Vintage Properties Pty Ltd – Cedar Woods

Built form for Stage 1A (101-105) comprising 39 two-storey row dwellings and associated land division (creating 41 allotments, including 2 large allotments for future development)

Semaphore Road and Causeway Road, Newport

040/D046/19

Figure 4 – Street Interface with Road 6

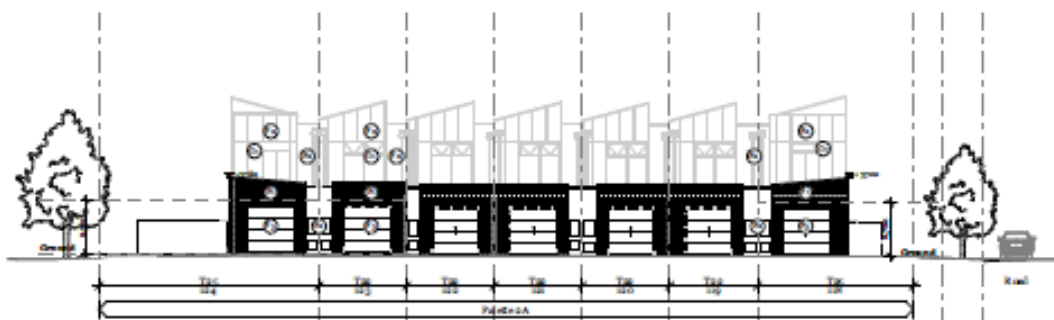
Road 6 is to act as the 'back end' for the dwellings and will be somewhat dominated with solid metal garaging, not resulting in an overly pedestrian friendly street interface – see *Figure 4* below. To improve the street presentation to the rear of this Stage 101/Road 6, consideration of material variation of garage doors to semi-transparent or perforated materials has been suggested by the GA. The applicant has noted this suggestion, however they consider this amendment not necessary given '*...Stage 102 has been designed with balconies that overlook Road 6 to provide passive surveillance*'.

Figure 5 - Rear Elevations for Stages 103 & 104

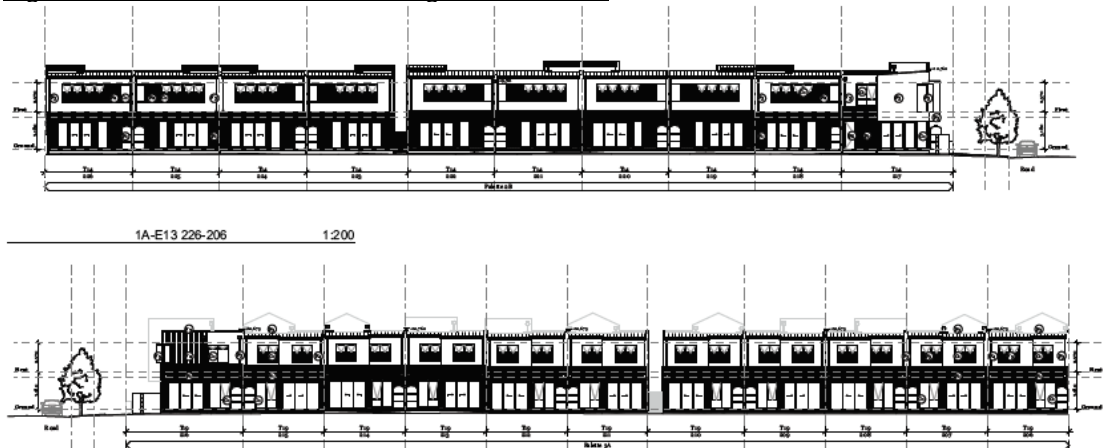
improve daylight access and articulation of the end facades. Further, while support for the built form articulation provided to the street facing elevations is given, the GA has raised concern with the presentation of the dwellings to the rear 'internal' elevations (when viewed from the private open space areas) and lack of built form articulation – see *Figure 5* below.

While further consideration of built form articulation of these rear 'internal' elevations with a view to reflect the articulated street elevations has been recommended, the applicant has indicated that they consider the built form articulation to the rear of the dwellings suitable. Although the rear elevations of the row dwellings will provide little visual relief with a mostly unbroken mass/façade, these elevations are deemed acceptable on balance. The dwellings in these stages will provide a reasonable level of 'outdoor' amenity with generous sized balconies (12m²) to their respective front elevations as well as limited outlook to these 'internal' elevations from most areas within the dwelling (obscure glazing to rear upper level windows for example) albeit the amenity within the POS areas is not considered ideal.

Figure 7 – On-Street Parking Availability

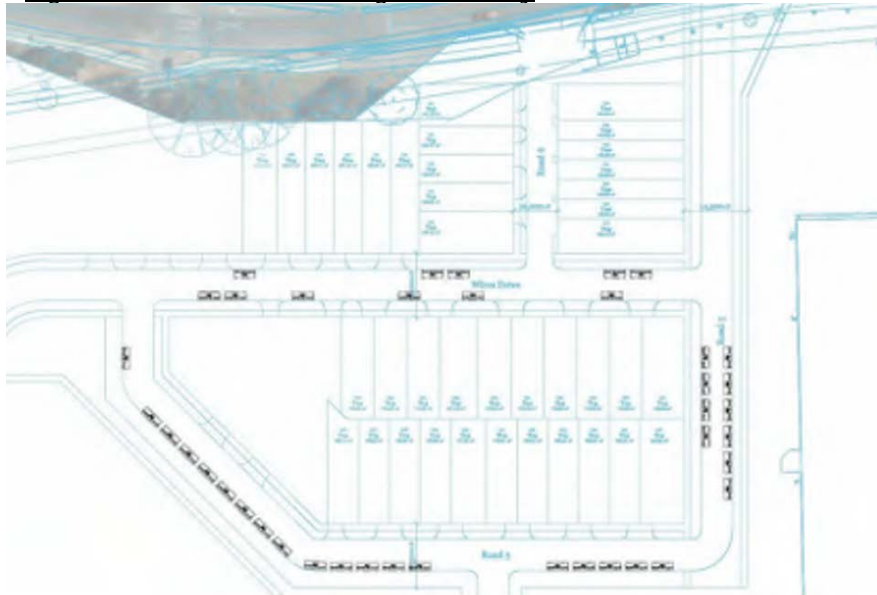
Based on a total of 39 dwellings, Stage 1A generates a demand of 78 off-street spaces and 13 on-street parking spaces. In this case, 32 of the dwellings provide 2 off-street spaces with 7 dwellings (forming part of stage 101) only provide 1 off-street space via a rear carport, resulting in a theoretical shortfall of 7 spaces.

GTA have outlined that 43 surplus on-street car parking spaces were identified as part of the super-lot development application and will ensure adequate provision for overflow for the 7-space off-street shortfall within or in proximity to Stages 101-105. With a surplus of 43 on-street car parking spaces, the resultant theoretical shortfall still provides 36 on-street spaces within the North Western Precinct - see *Figure 7* below.

Figure 1: Road 5/Wirra Drive Driver Sightlines

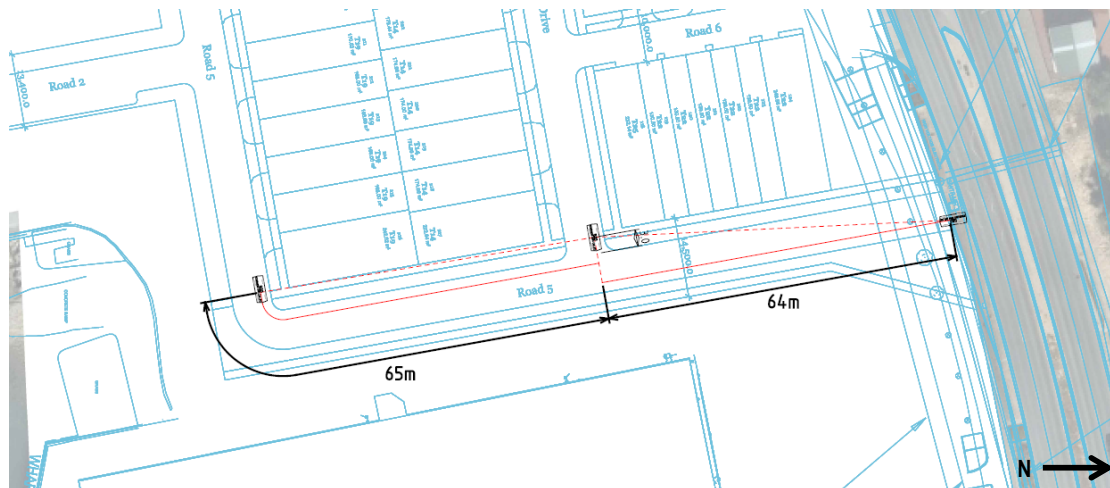
The available sight distance at the Road 5/Wirra Drive intersection is outlined in Figure 1. The desktop review indicates approximately 65m and 64m of sight distance will be available to the north and south respectively, exceeding the SISD and MGSD requirements for a 35km/h design speed.

Therefore, based on the desktop assessment, the intersection meets the sightline requirements for a 35km/h design speed, without being impacted by fences/structures built along the property boundaries.

Figure 2: Road 6/Wirra Drive Driver Sightlines

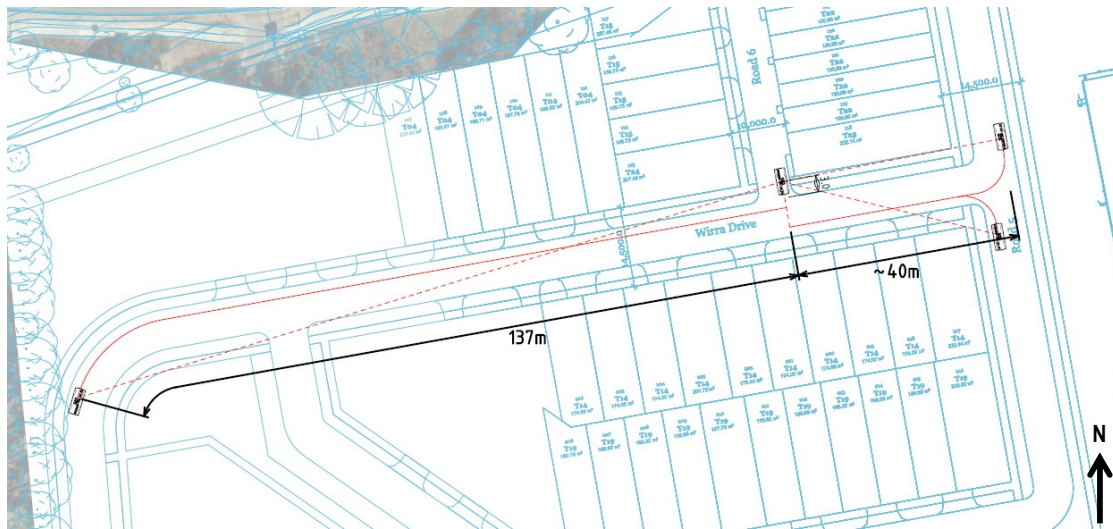
The available sight distance at the Road 6/Wirra Drive intersection is outlined in Figure 2. The desktop review indicates approximately 40m and 137m of sight distance will be available to the east and west respectively. This exceeds the SISD and MGSD requirements for a 20km/h design speed to the east and 60km/h design speed to the west, without being impacted by fences/structures along the property boundaries.

Figure 3: Wirra Drive/Road 6 Pedestrian Sightline – Low Level Plantings

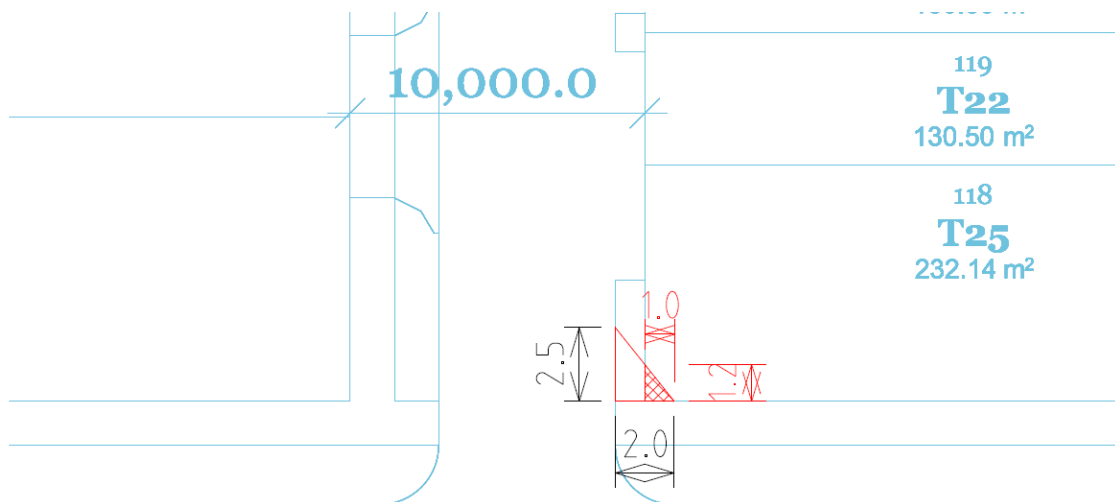
It is understood that the property boundary lines associated with Allotment 118 are to provide a 1.0m wide by 1.2m wide corner cut off to accommodate the pedestrian sight play requirements, as shown in Figure 3.
